FINAL PLAT
MINNEHA ELEMENTARY SCHOOL ADDITION
AN ADDITION TO WICHITA, SEDGWICK COUNTY, KANSAS

RE: SUB 2001-128 MINNEHA ELEMENTARY SCHOOL ADDITION

STAFF REPORT
(One-Step Final Plat)

CASE NUMBER: SUB 2001-128 – MINNEHA ELEMENTARY SCHOOL ADDITION

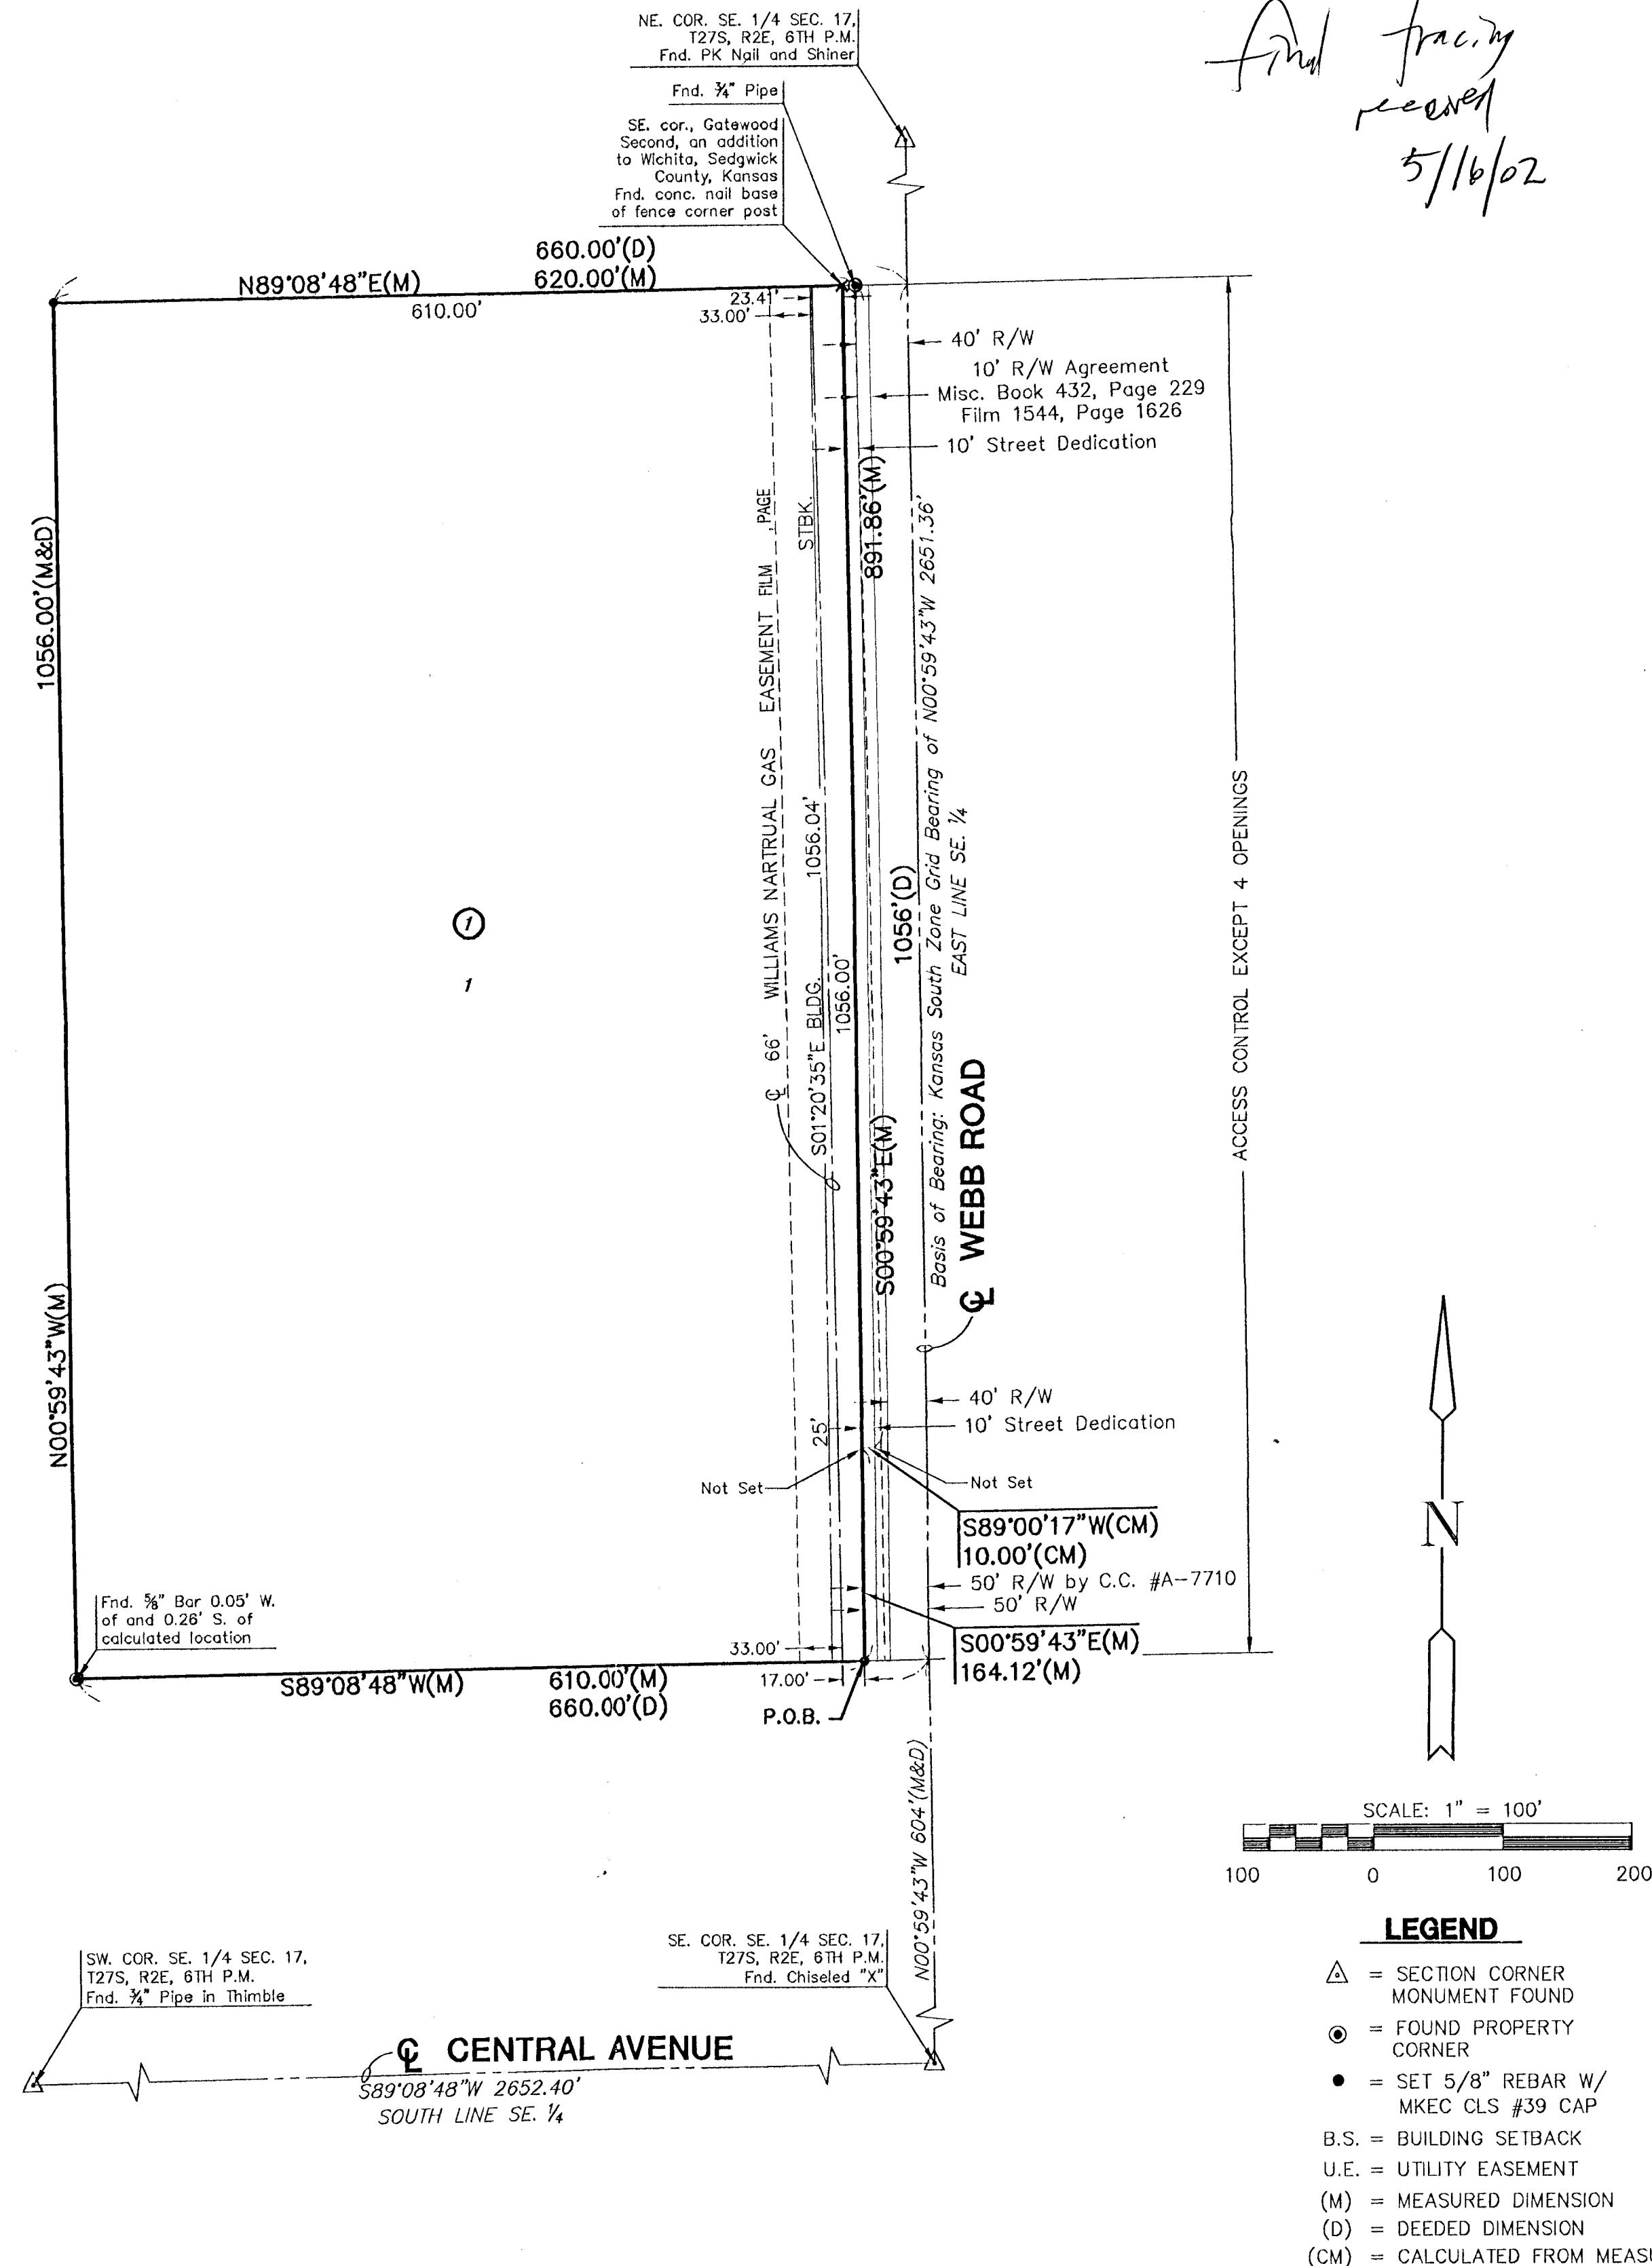
- C. City Engineering needs to comment on the status of the applicant's drainage plan. The drainage plan is approved.
- D. The plat proposes four access openings along Webb. Distances should be shown for all segments of access control. The access controls are approved.

- E. The applicant shall guarantee the closure of any driveway openings located in areas of complete access control or that exceed the number of allowed openings.

- H. The platator's text shall include language that a drainage plan has been developed for the plat and that all drainage easements, rights-of-way, or reserves shall remain at established

grades or as modified with the approval of the applicable City or County Engineer, and unobstructed to allow for the conveyance of stormwater.
